Re: **Solicitation Addendum No. 01 to RFP #HHSC FY 25-0437 Parking Lot Expansion & Covered Drop-Off MOB 1 & MOB 2 Project.**

HILO BENIOFF MEDICAL CENTER
PARKING LOT EXPANSION & COVERED DROP-OFF
MOB 1 & MOB 2
1285 WAIANUENUE AVENUE HILO, HAWAII 96720
TAX MAP KEY: (3) 2-3-031.019

Re: **Solicitation Addendum No. 02 to 25-0437 RFP PARKING LOT EXPANSION & COVERED WALKWAY DROP OFF MOB 1 & 2 QUESTIONS & ANSWERS; SECTION 13286 – MANAGEMENT OF IMPACTED SOIL**

SHEET:
C04.1

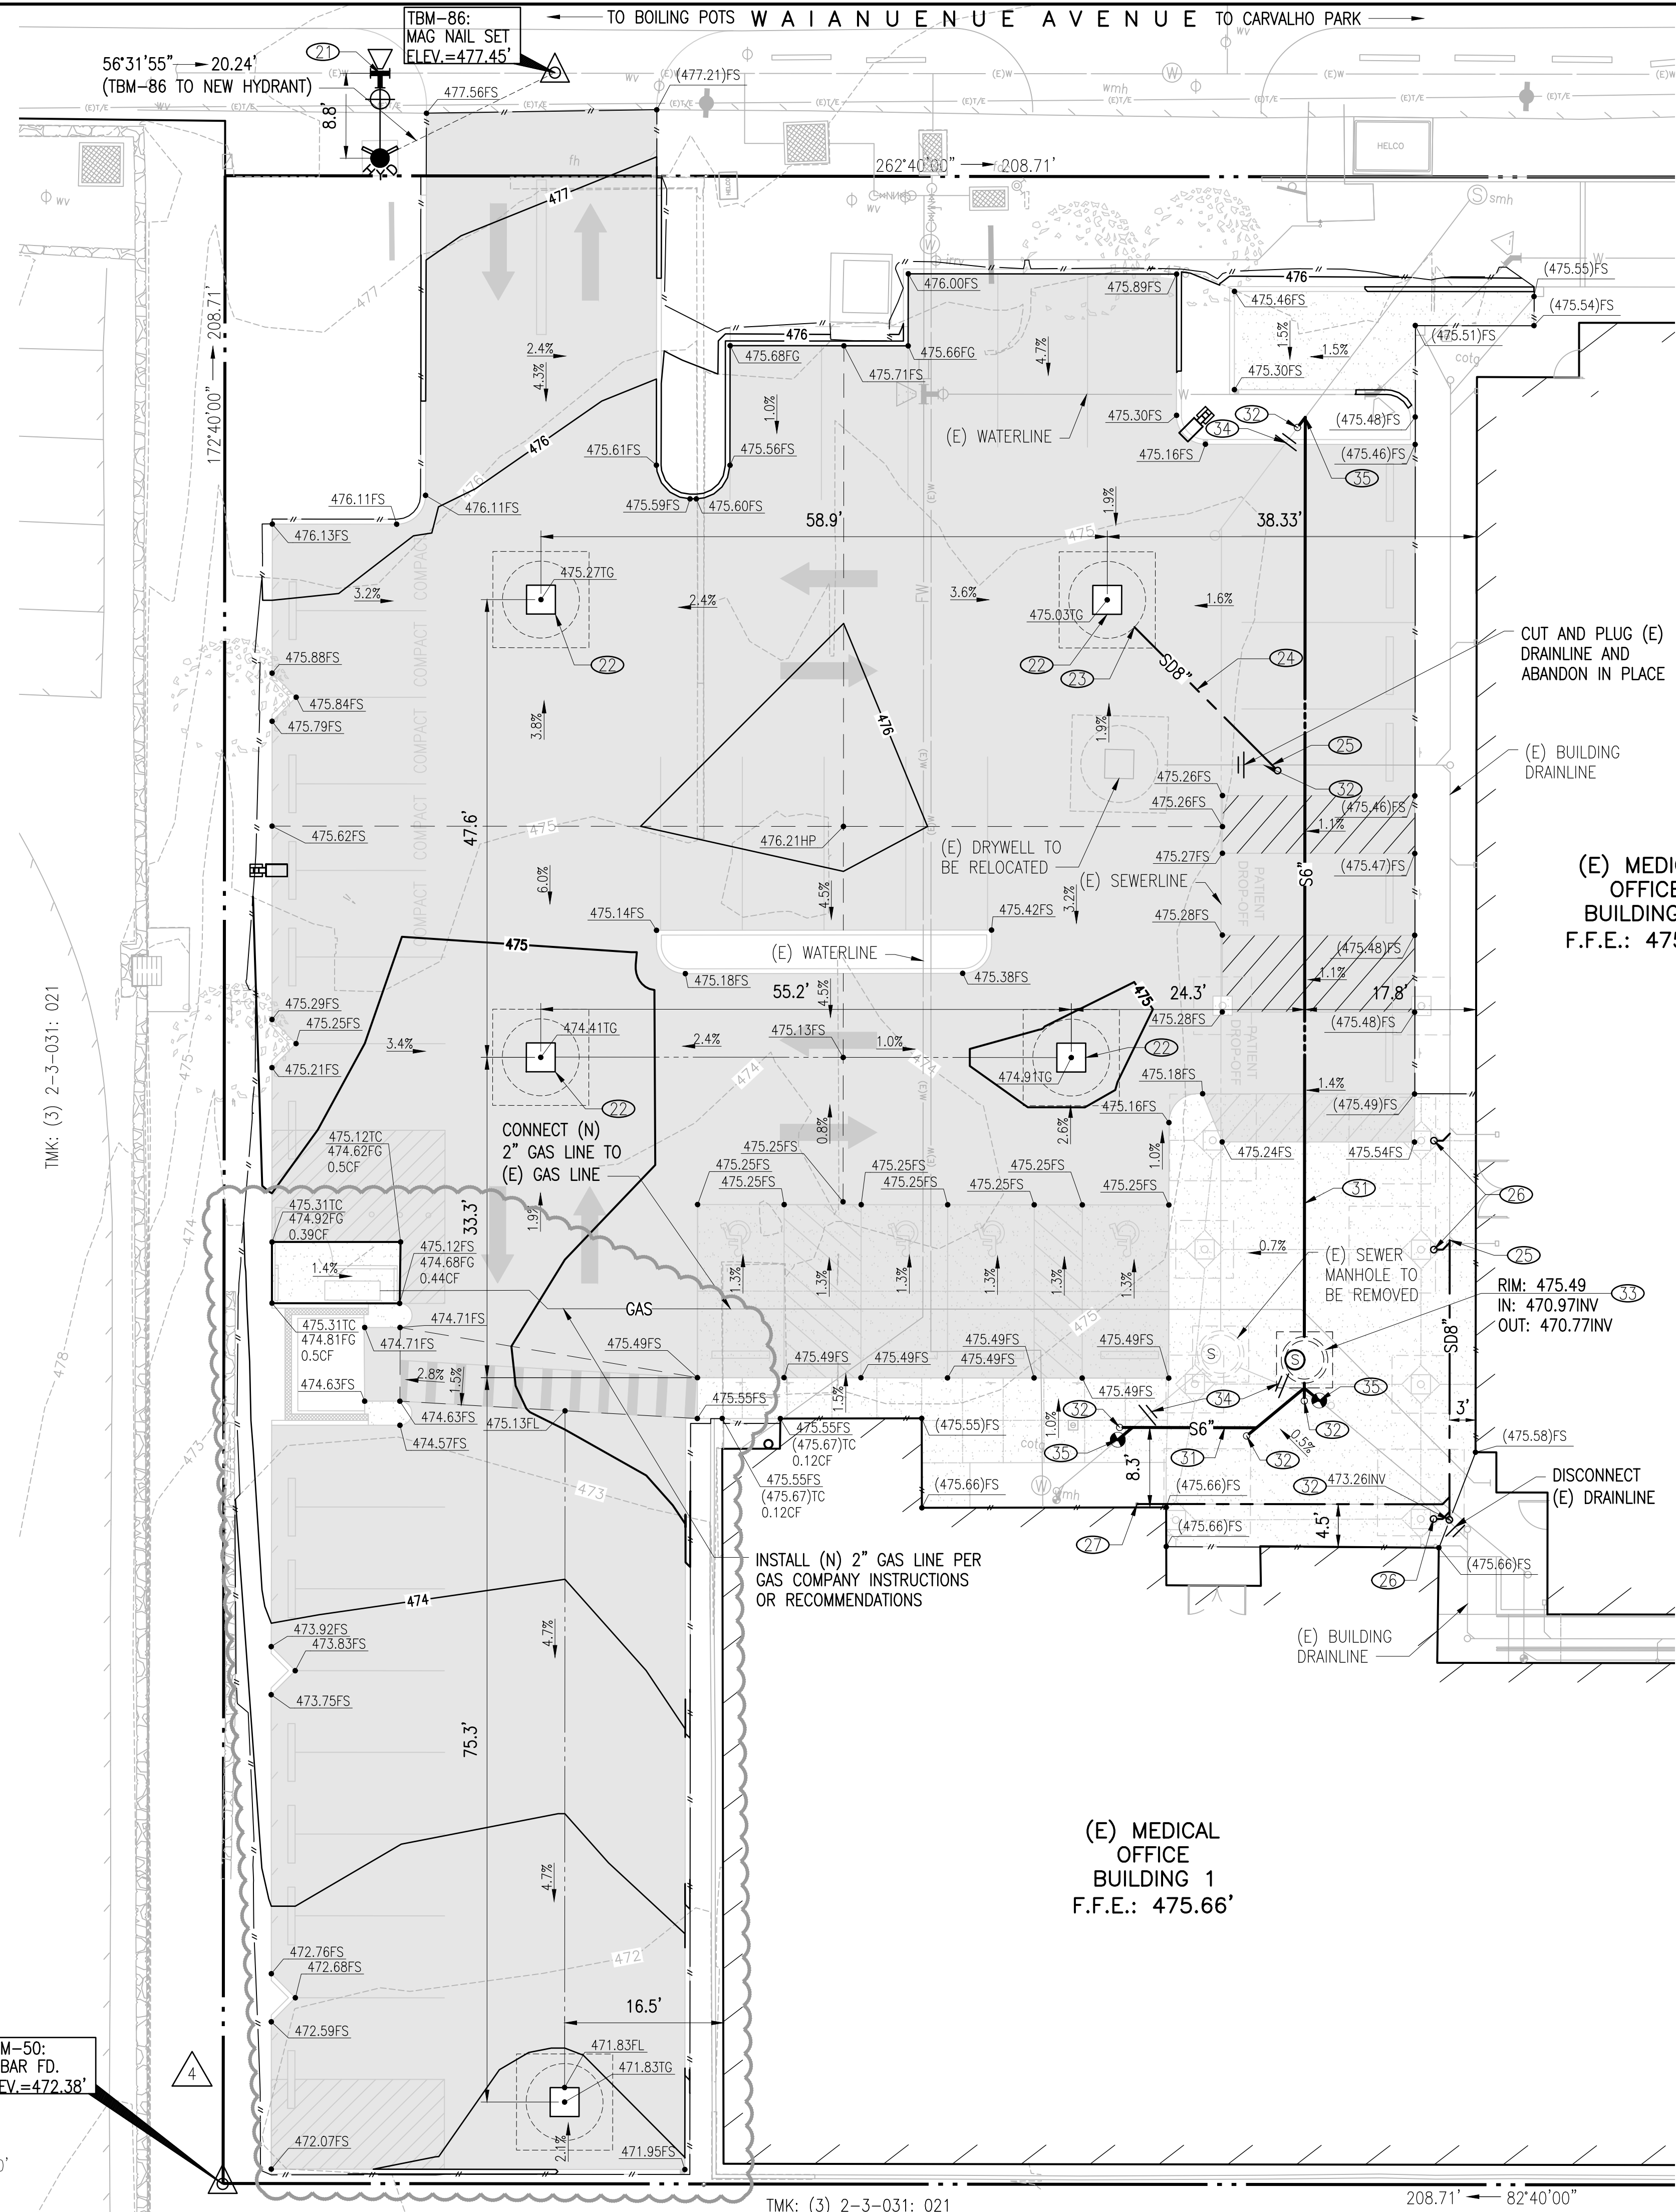
This addendum provides a change to the proposed new parking lot and the location of the trash enclosure and propane gas tank and are being provided to all offerors to assist in proposal preparation.

REVISIONS		
No	Description	Date
4	PROPOSED PARK RELOCATION	6/16/25

SHEET:
A02.3

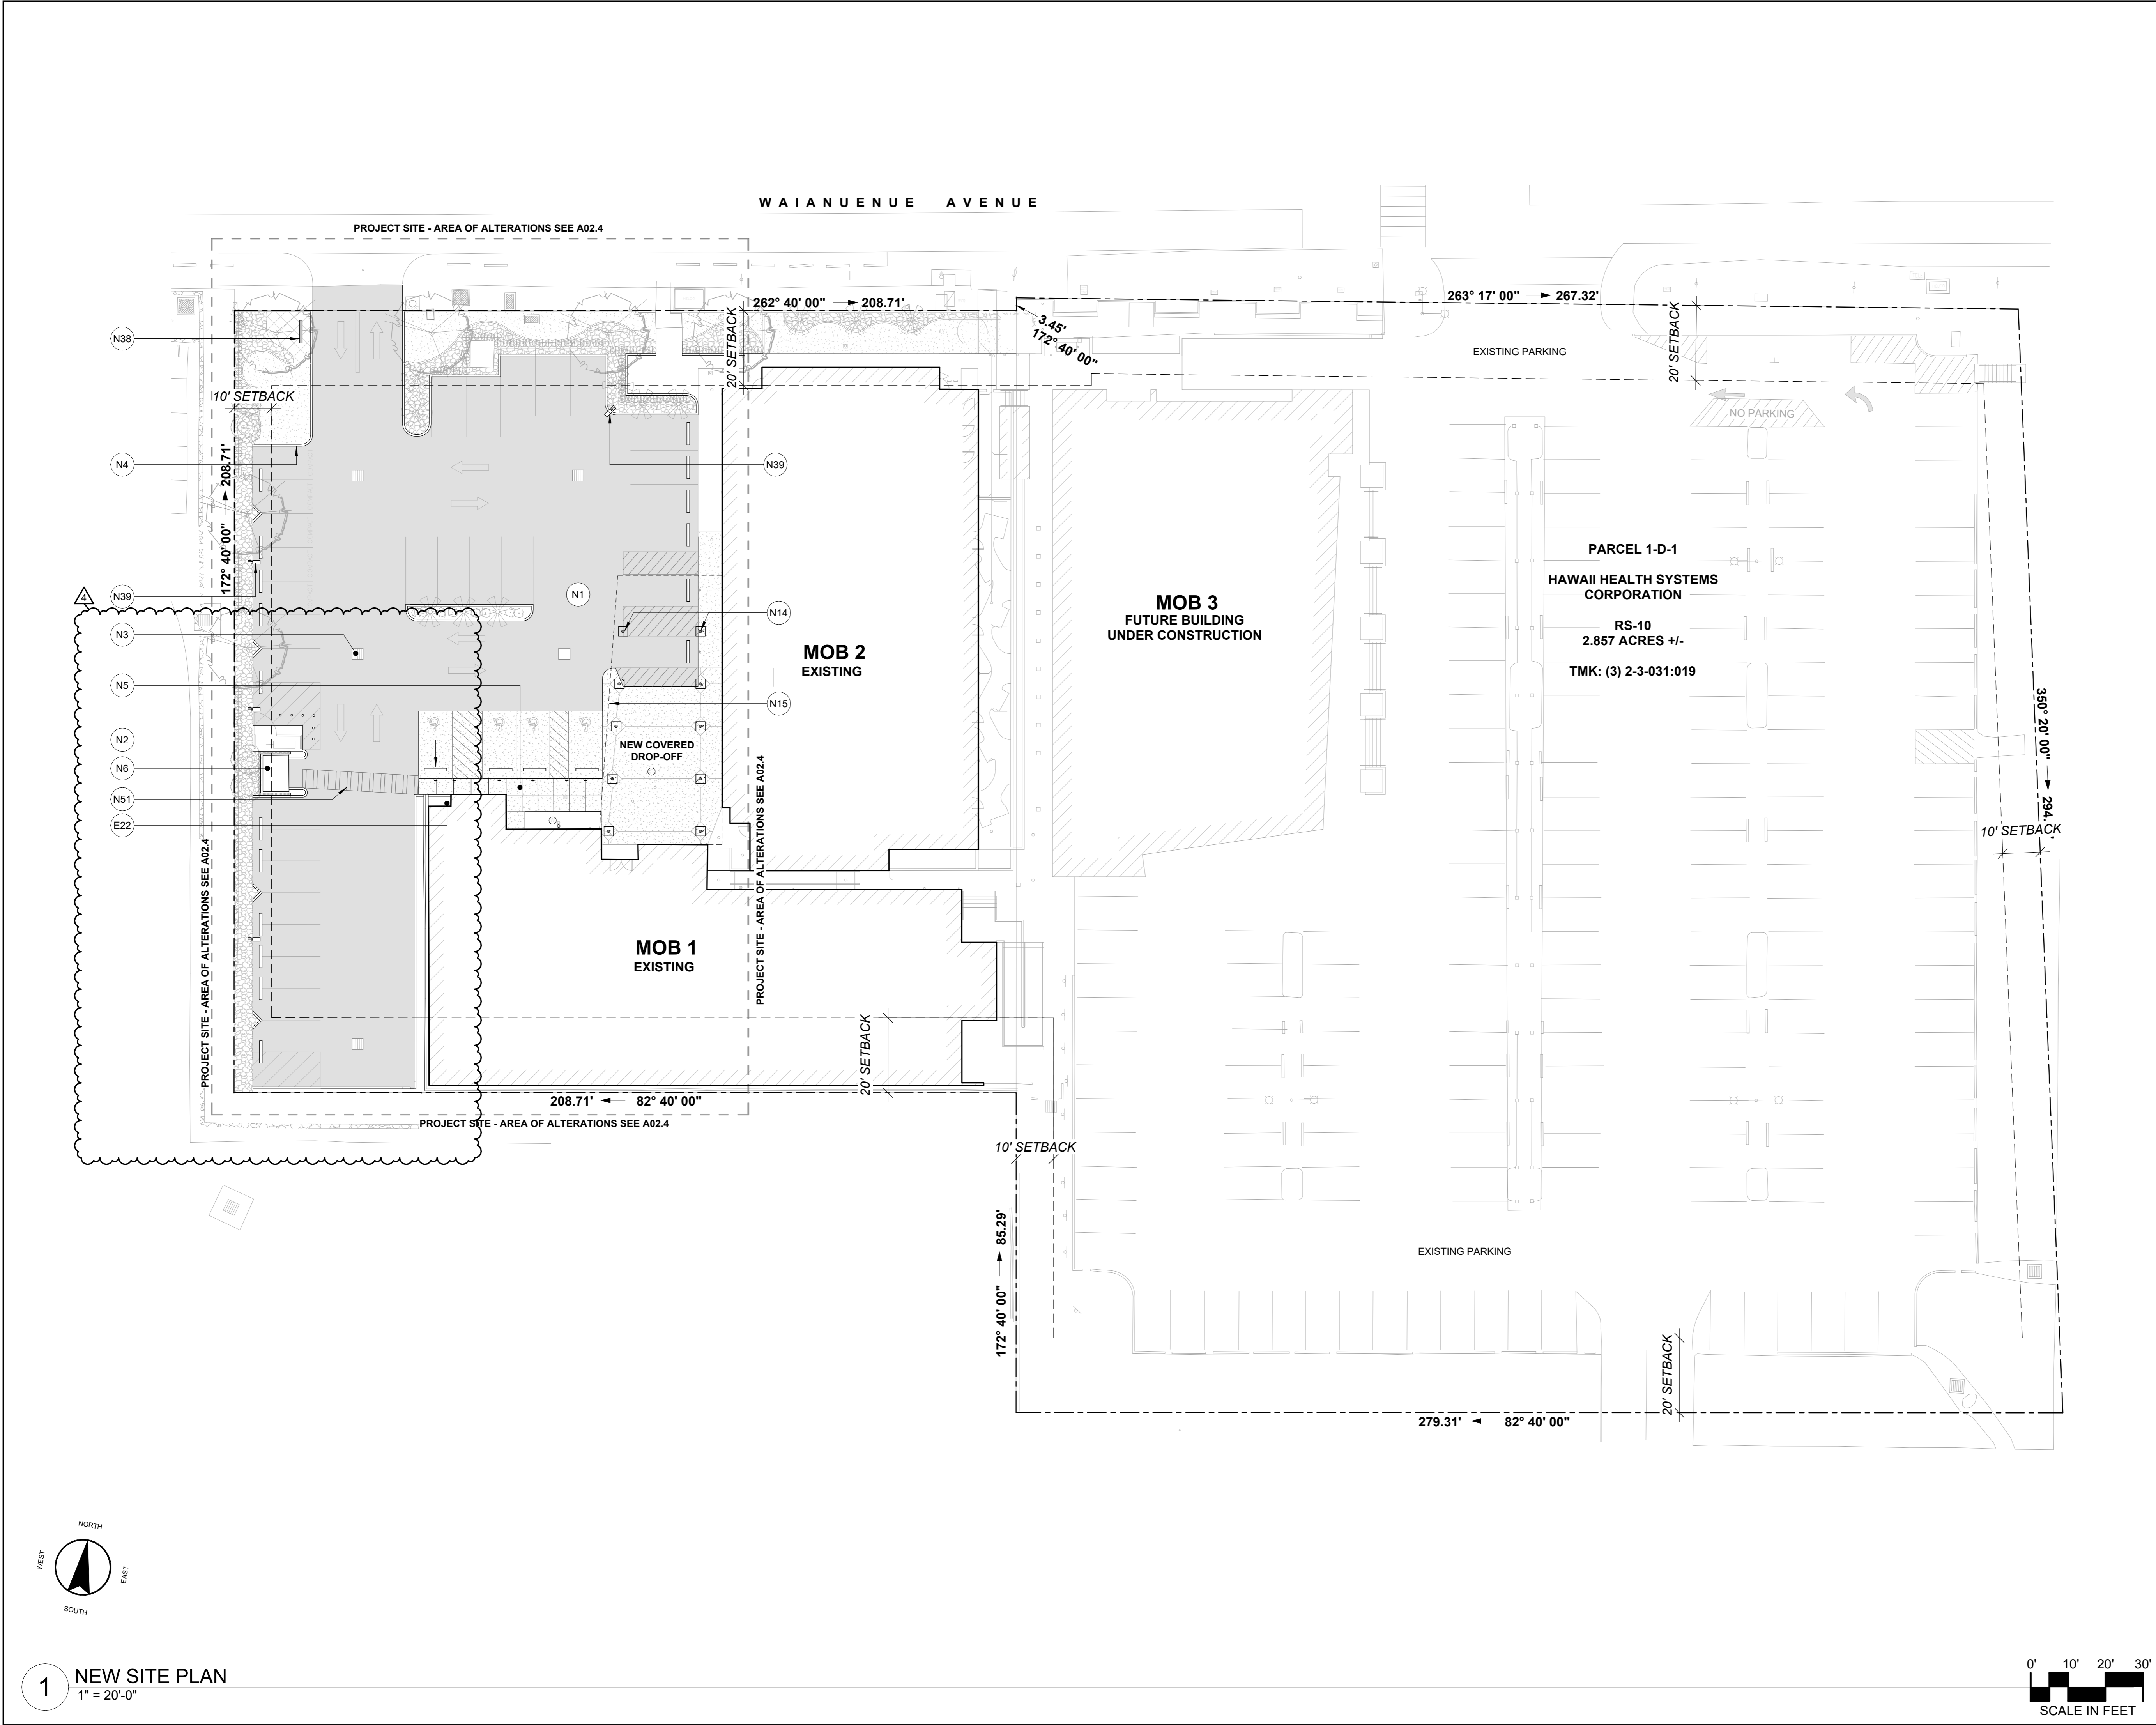
No	Description	Date
4	Propane Tank Relocation	6/16/25

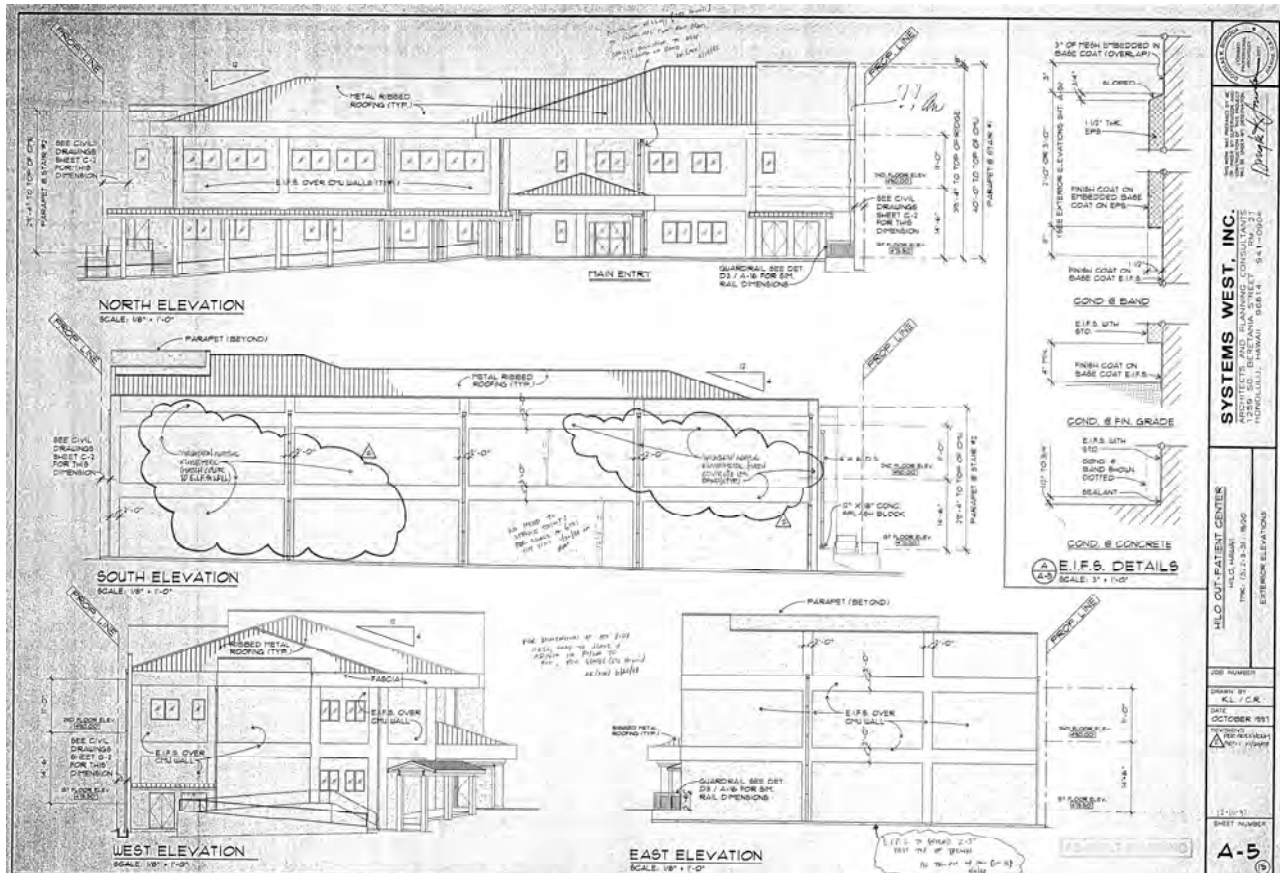
- Q1. Do you know what type of metal gutter this is to be? The spec doesn't call out the gutter material specifically. Detail 3/A07.1 shows the other gutter, which is unmarked, but we also assume to be metal. As the architect replies, would you also be able to find out how they envisioned the gutter to tie-in to the single-ply roofing?**

- A1. The gutter is not metal as noted on detail 5. The gutter is integral with the TPO roofing. This is the same gutter design used on MOB 2 & 3. The gutter is 12" wide x 7" deep.

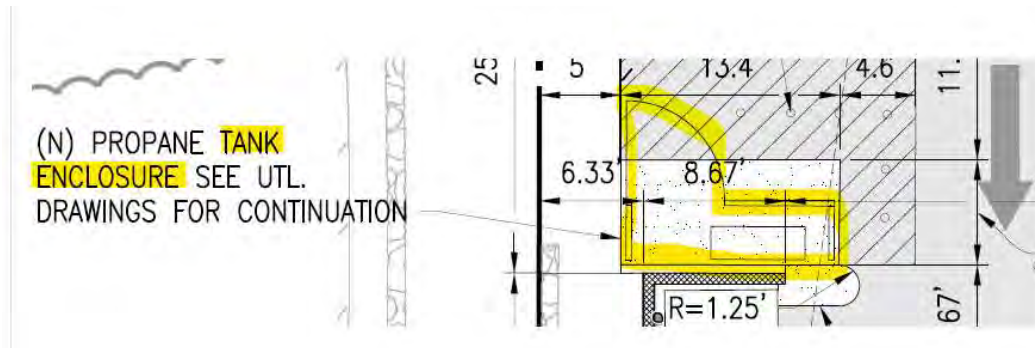
- Q9. Caught this on the Addendum 1 drawings, Sheet C03.1. See highlighted below, call-out states “propane tank enclosure”. The drawing outlines an “enclosure” around the new propane tank. There is no detail provided for the propane tank enclosure. Request detail for propane tank enclosure.

- A9. The GC is instructed to remove and relocate the propane tank and the enclosure on sheet A03.1

SHEET CONTENTS:	
DEMOLITION FLOOR PLAN	
DATE:	OCT., 2024
SHEET:	
A03.1

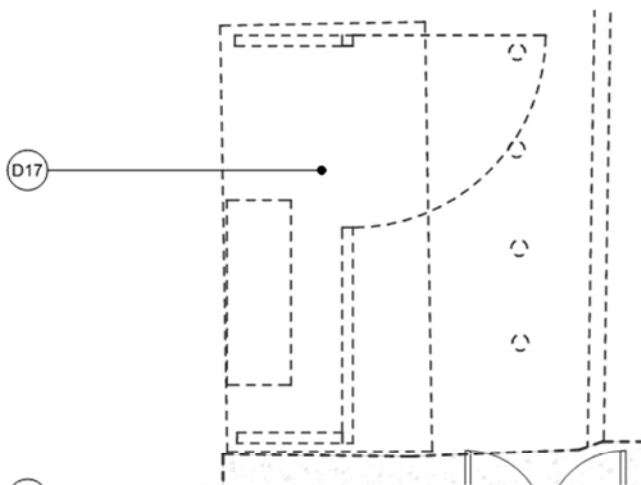
- D8 REMOVE CONC WALK, SCD
- D17 REMOVE/RELOCATE GAS TANK & ENCLOSURE, SCD
